## **REMARKS**

# ANNOTATED SHEET

FIG. 1

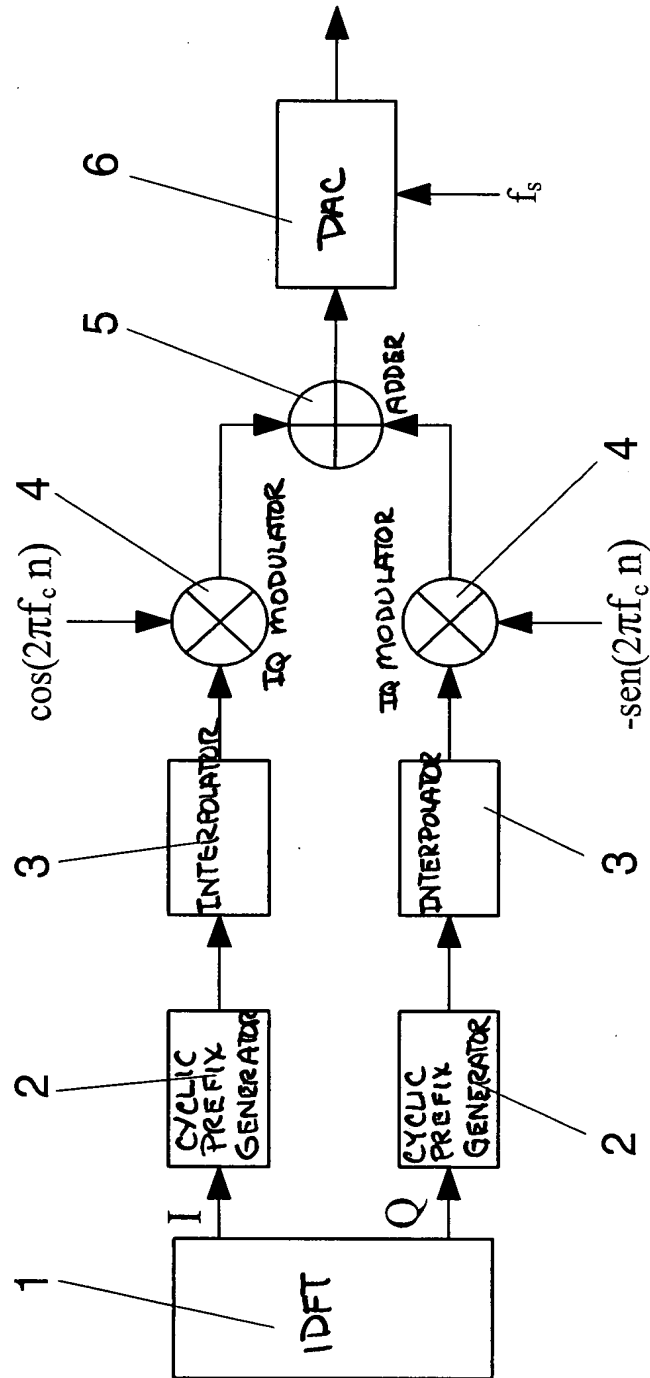
The Examiner has objected to the drawings and particular, to figures 1, 2, 3 and 7 on the basis that labels for certain of the elements are not present. Applicants have prepared corrected drawings which are submitted herewith as four (4) sheets labeled "REPLACEMENT SHEET" and have also submitted a corresponding set of marked-up copies of the said drawings, reflecting the originally presented drawings having markings thereon to include the labels requested by the Examiner. Both sets of sheets are enclosed herewith and it is believed that the enclosed sheets represent full and complete compliance
